L-PI-08-014
TS 5.6.5.d

Core Operating Limits Report (COLR) for Prairie Island Nuclear Generating Plant (PINGP) Unit 1 Cycle 24, Revision 2 and Unit 2 Cycle 24, Revision 3

UNIT 1 – CYCLE 24, REVISION 2

UNIT 2 – CYCLE 24, REVISION 3

Figure 6A

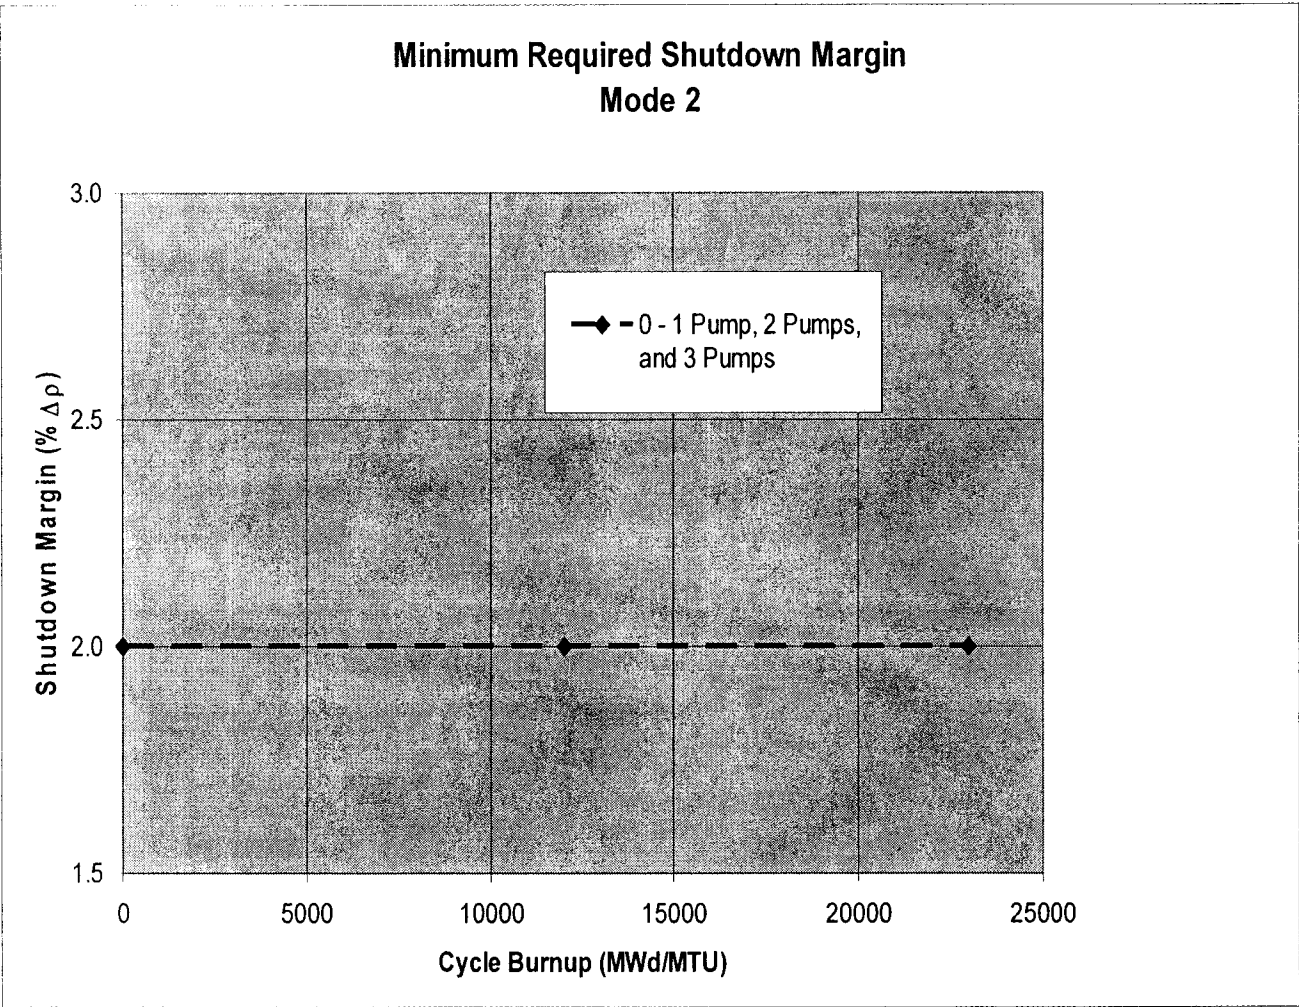
- Revised Section 3.1.1 Shutdown Margin Requirements, to include a reference to Figures 6A through 6H.
- Revised Section 3.1.8 Physics Test Exceptions – MODE 2, to include a reference to Figure 6B.
- Revised item c) of Section 3.9.1 Refueling Boron Concentration, to include a reference to Figures 6A through 6H.
- Updated Table 1 to reflect the correct Shutdown Margin Requirements.
- Added Figures 6A through 6H.

Minimum Shutdown Margin requirements are shown in Table 1 and Figures 6A through 6H.
